Office Action Summary

10/524,599

BREITENBACHER ET AL.

FIG. 1

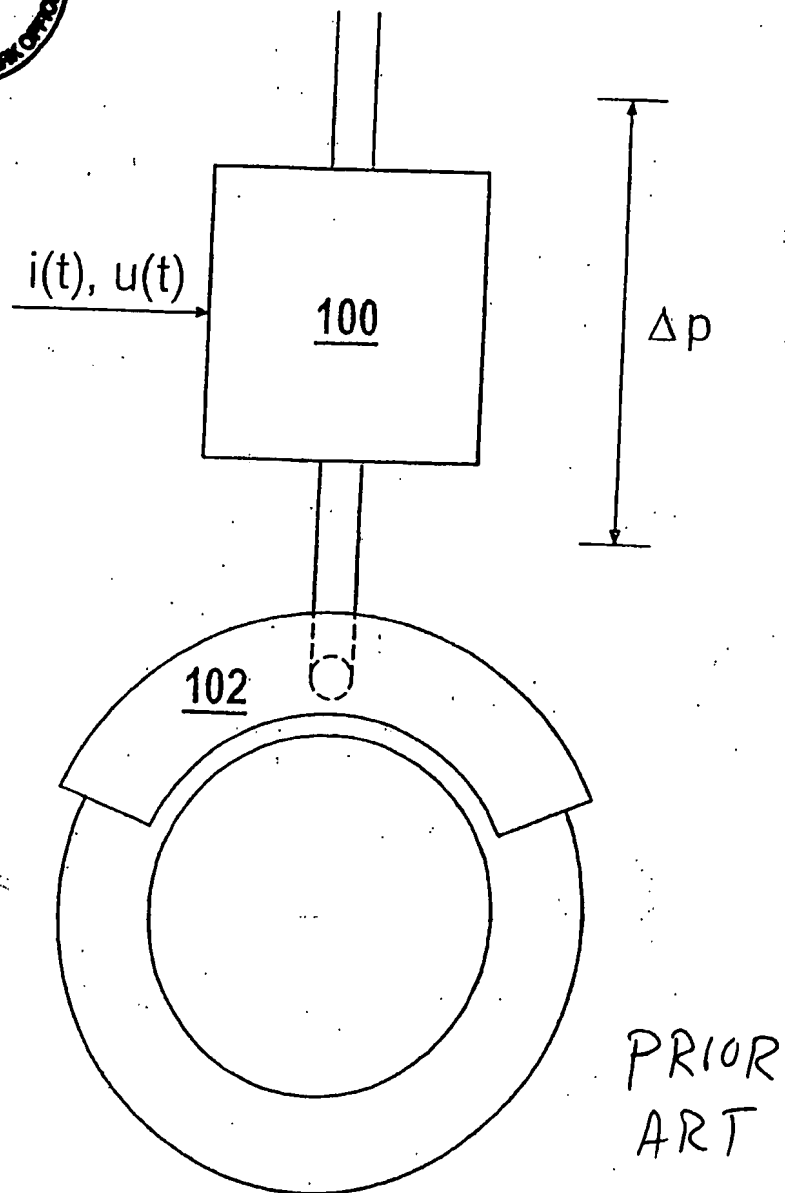
approved
XUN
7/5/07
